RFI Response - Pertaining to: Application No. MCU/2025/115

Environmental and Landscape Assessment

7-9 SURF PARADE

RFI1 LANDSCAPE ITEMS

SPATIAL CONSTRAINTS - DEEP PLANTING / FIRE BOOSTER

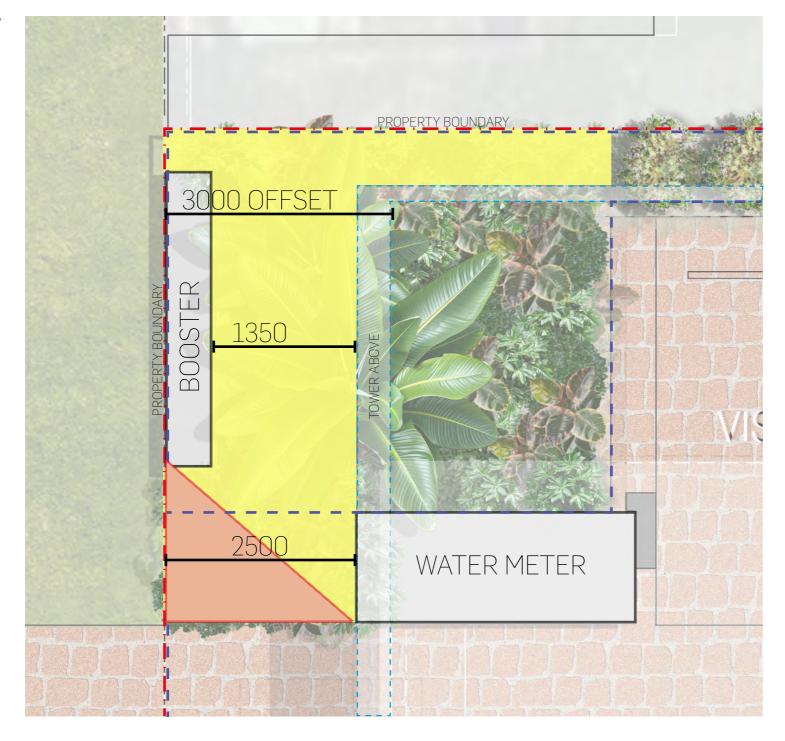
Officers have identified several concerns with the proposed landscaping at the frontage:

- The deep planting area is obstructed by the booster cabinet.
 - Urbis is referring to the front boundary planter as deep soil, not deep planting, given the services and built form above and below. We consider the planting area and available height to building over sufficient for the plants identified in the SLI planting palette, with the proposed feature Strelitzia the best plant for the project based on the current architectural design.
- The basement wall is located along the front boundary, separating the deep planting area and the verge.
 Refer architectural package for basement wall location. Landscape plans reflect this zone as having deep soil but not deep planting, due to services, structure above and below.
- No set down has been proposed for the central garden bed.

- a. Ensure that no basement wall or planter wall be constructed between the basement set-down area and the public road verge.

c. To facilitate tree planting, incorporate a minimum of 500 mm recess / articulation in the building set back to allow for an evergreen canopy tree to be planted in the deep planting area, ensuring 3m clearance from the building line

d. Reorient the booster cabinet away from the front boundary so that it is positioned parallel to the side boundary.

There is a 288mm set down in the central garden beds flanking the arrival path. With the seating element forming the planter walls soil depth of 500mm is achieved and with localised mounding the planters are shown as 600mm deep soil for shrubs and groundcovers.

Refer also architectural package. The northwestern corner planter at the ground floor is the only planter connecting to the public road verge basement wall is shown as set back from the verge, with sufficient soil to support proposed planting.
- b. Provide one tree planting area along the frontage, within the deep planting area.

Per discussion with council 22 May 2025, the constraints of the planting location along the frontage limits the ability for a tree to thrive in this location. Strelitzia nicolai (Giant Bird of Paradise) has been selected to meet the planting and space conditions.

We have considered and designed around the many constraints within this planting zone.

It is not possible to achieve a 3m offset from the built form due to:

- Fire Booster location
- Sight triangle
- Tower over
- · Proximity to water meter

A shade canopy tree in this location would be constrained by services and overhead built form, limiting its ability to provide shade. A tree would also be largely obscured from the street if placed behind the booster.

Using Strelizia nicolai in this location allows for a plant of scale that is able to provide day one impact, responds to the constraints of the space and the built form, and speaks to the subtropical, deep green planting palette.

MAINTENANCE & ACCESS

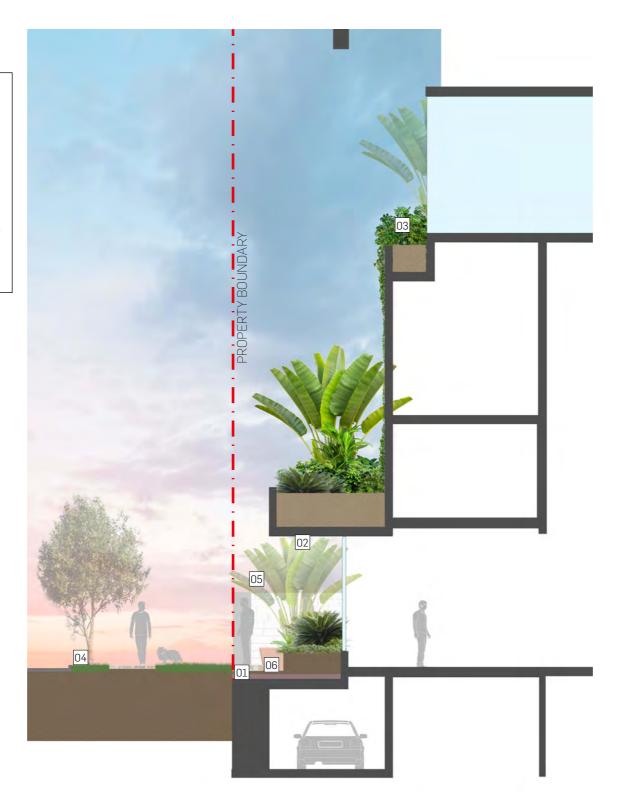
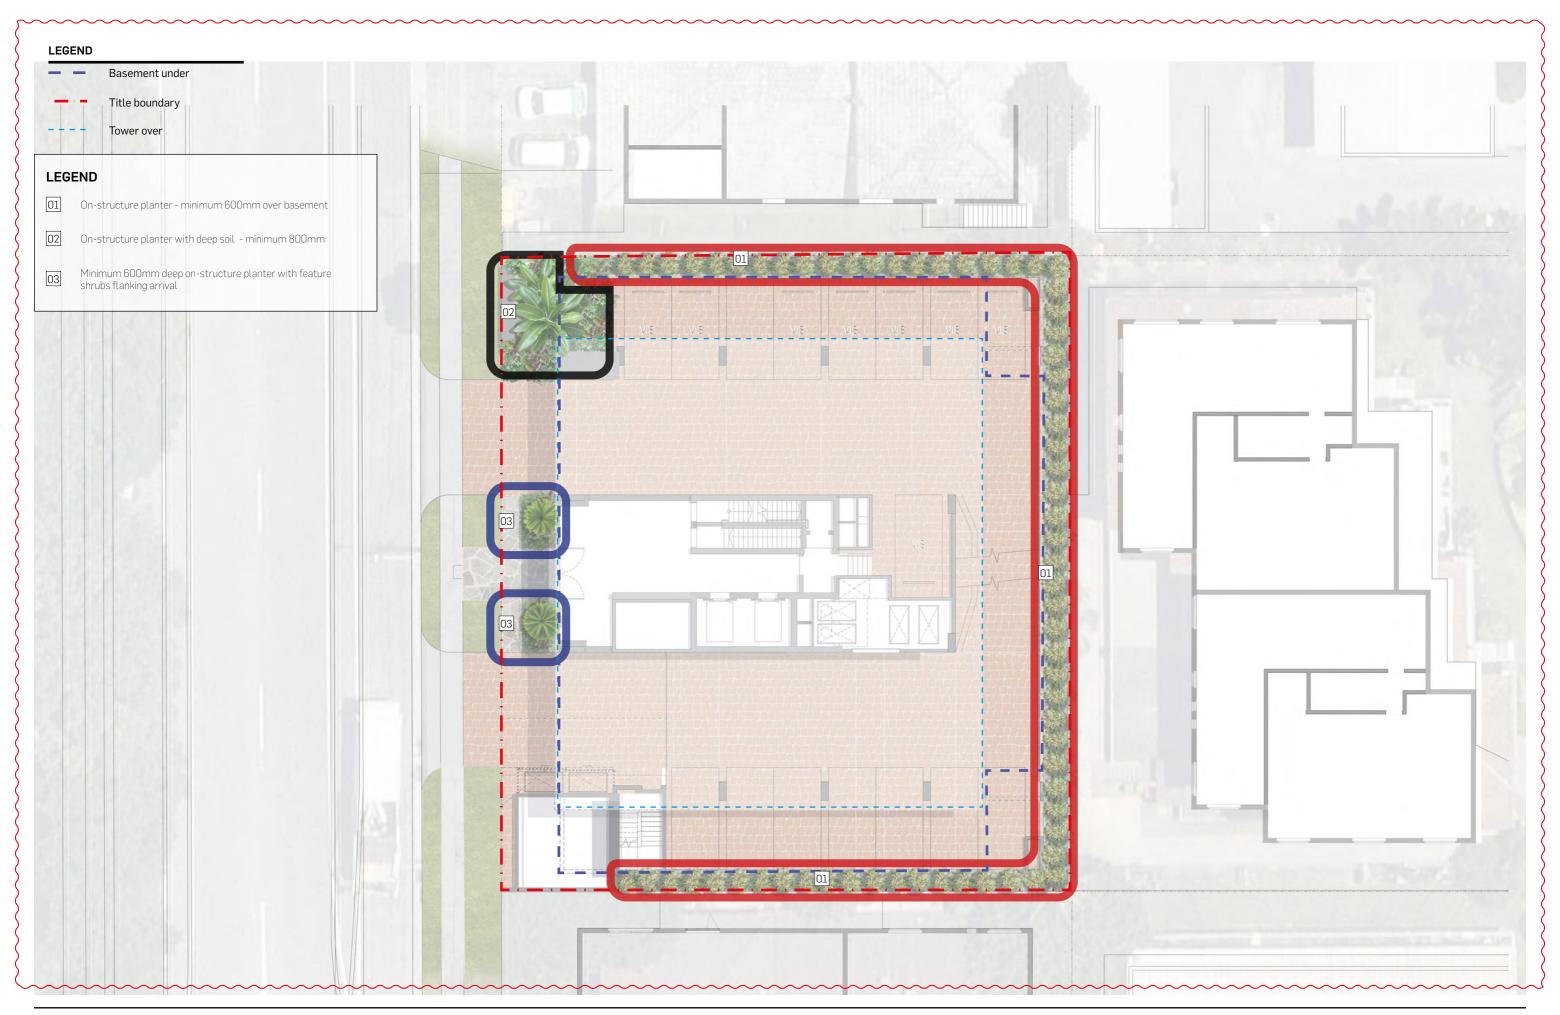
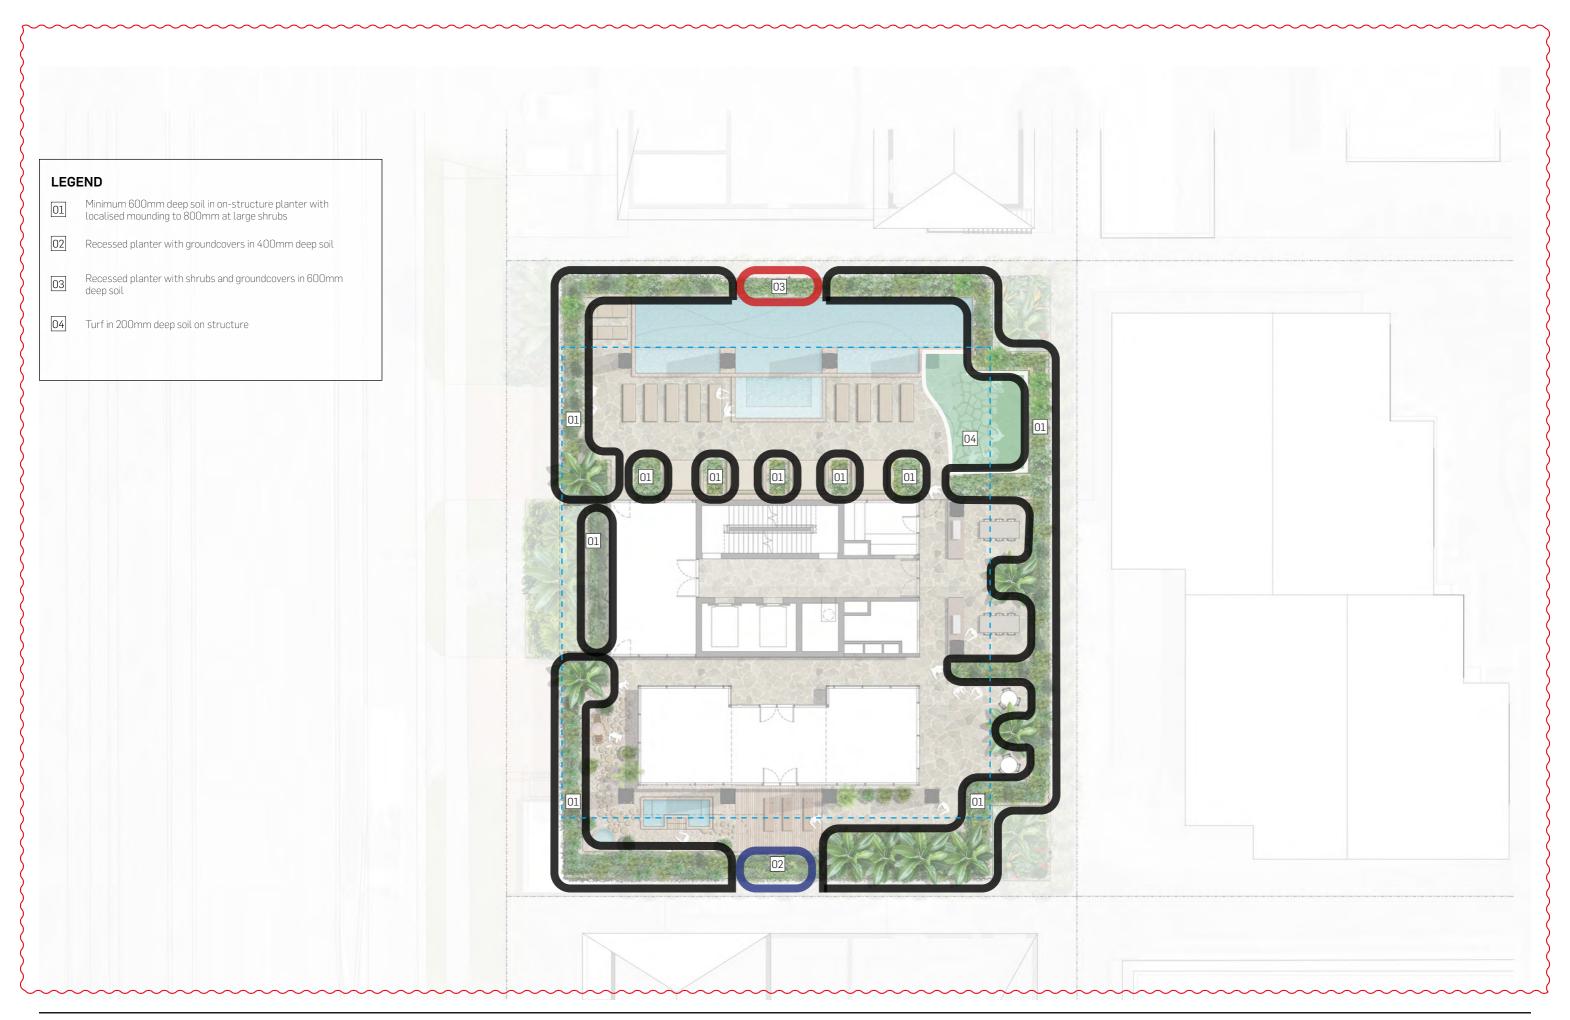
There are inconsistencies between the provided Architectural drawings and SLI in relation to the proposed planter depths across all podium levels. Additionally, the site boundary setbacks range between 900mm and 1m with perimeter feature planters. Officers also raise concerns regarding accessibility and maintenance of the planters.

- a. Demonstrate that the proposal can achieve a long-term resilient landscape outcome, and ensure the following parameters are met for all planter boxes:
 - i. A minimum soil depth is 600mm for shrub planting.

Minimum 600mm depth is shown for all planters with shrubs.

Planters with scrambling species only (draping plants) are shown as 400mm deep soil.

Turf or turf alternatives are shown in 200mm deep on-structure planting medium.

- Typical on-structure planter profile with low shrubs and groundcovers, mounded to approx 600mm soil depth, with placement of taller shrubs outside of sight triangle
- On-structure planter with larger, feature shrubs, layered planting of shrubs, groundcovers and climbing species, in 600mm deep soil
- On-structure planter with small and medium shrubs, layered with groundcovers and draping plants, in 600mm deep soil
- [04] Existing street tree retained Cupaniopsis anarcardoides (Tuckeroo)
- Layered planting with feature Strelitzia nicolai in deep soil planter, with layered shrubs and groundcovers at northwestern boundary
- O6 Seating element forms the planter walls and bookmarks arrival path

Maintenance access for all planters above ground has been considered in the current design. The current design provides a range of opportunities for all planters to be accessed for maintenance. The methods of maintenance for each planter may vary once an accredited access consultant is engaged in future phases however efforts have been taken at this conceptual stage to ensure methods as per below are possible:

- Access to gardens from inside the balustrade line (preferred and wherever possible). we have worked with the architect to ensure glass balustrades are minimised to allow for a maintenance person to reach through an open slat style balustrade for maintenance.
- Static line in garden. This is the preferred option which will be undertaken as a detailed design exercise with the builder, architect, structural engineer, facade engineer, access contractor and landscape architect to ensure the static line is designed into the built form to ensure it is practice and usable for working at heights.
- Abseiling. Whilst this is the most common method of accessing planters outside of balustrade lines, we have aimed to reduce the need for this given it's risk profile. It will however be considered in the detail design phase.

TECHNICAL INFORMATION

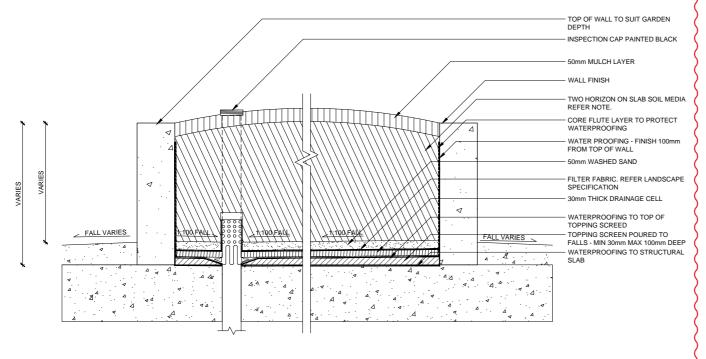
ii. A minimum soil depth is 1m for tree planting.

No trees are shown on this project. Strelitzia nicolai is called up as a large shrub, with adjusted soil volume 800mm in 1m overall planter or via localised mounding, to allow for larger root system. Strelitzia is shown on podium where localised mounding to 800mm is achieveable.

TWO HORIZON PODIUM SOIL MEDIA FROM TOP DOWN:

HORIZON A - HIGH ORGANICS MAX.300mm DEEP HORIZON B - LOW ORGANICS DEPTH VARIES FOAM BLOCK OUT (OF REQUIRED TO ACHIEVE FINISHED LEVELS)

The soil depths as shown in the planting depth diagrams are suitable for the long term viability of a planting palette that is robust and hardy.

The soil that will be specified for the on-structure areas will be an engineered lightweight low organic, two horizon profile. Horizon A will be maximum 300mm as it has some organic content. This depth has been established by Australia's leading soil scientist Simon Leake as the optimal depth to protect against slump and anaerobic conditions. Horizon B is a stable, low compacting, low to no organic profile that will make up the variable depths required.
